# Product Change Notice

**PCN Ref Nº:** PT-15 V with improved (flanged) collector

New flange close up

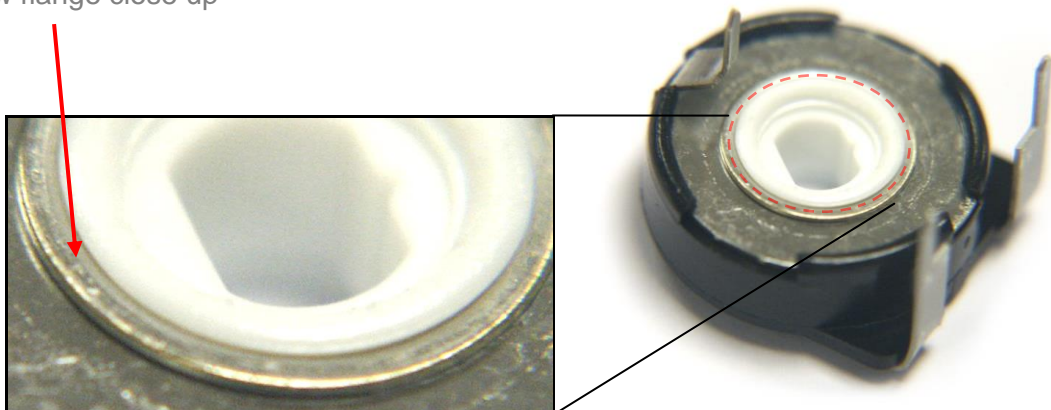
The collector for the PT-15 V model has been redesigned to include a flange near the rotor's hole. This change affords significant improvements in terms of rotational feeling and improved torque & hysteresis. All other product's specifications remain unaffected.

**REASONS FOR CHANGE:** Improved rotational feeling. More homogeneous torque.  
Improved hysteresis.
